| APPLICATION NO.  | FILING DATE | FIRST NAMED INVENTOR   | ATTORNEY DOCKET NO. | CONFIRMATION NO. |
|--|-------------|------------------------|---------------------|------------------|
| 10/578,421   | 05/05/2006  | Ki Ju Kang             | P/4761-4            | 1653             |

### Office Action Summary

## **DETAILED ACTION**

Annotated Fig. 4 (6,739,937)

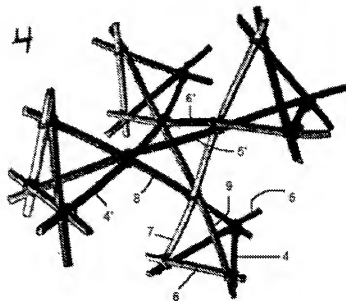
Snelson discloses a structure (Fig. 4 below) comprising:

*Claim 1 - a)* a first tetrahedron member formed of a first to sixth wires, the first tetrahedron member being constructed in such a manner that the first wire (4), the second wire (5), and the third wire (6) are intercrossed in a plane to form a triangle, the fourth wire (7) is intercrossed with the intersection point of the second wire and the third wire, the fifth wire (8) is intercrossed with the intersection point of the first wire and the second wire, and the sixth wire is intercrossed with the intersection point of the third wire and the first wire, the fourth wire, the fifth wire, and the sixth wire (9) being intercrossed with one another at a single reference intersection point; and

b) a second tetrahedron member contacted with the first tetrahedron member at the reference intersection point and having a similar shape to the first tetrahedron member, the second tetrahedron member being constructed in such a manner that the fourth wire, the fifth wire, and the sixth wire pass the reference intersection point and extend further, each of a group of wires (4', 5', 6') is intercrossed with two wires selected from the extended fourth, fifth and sixth wires, the group of wires being in parallel with the first wire, the second wire, and the third wire respectively; and

and the unit cell is repeated in a three-dimensional pattern, thereby forming a wire (or rod)-woven truss-type structure.

Finally, the Snelson-taught wire members need not be bonded at intersection points ("joining members are not required", para. 36, last sentence).
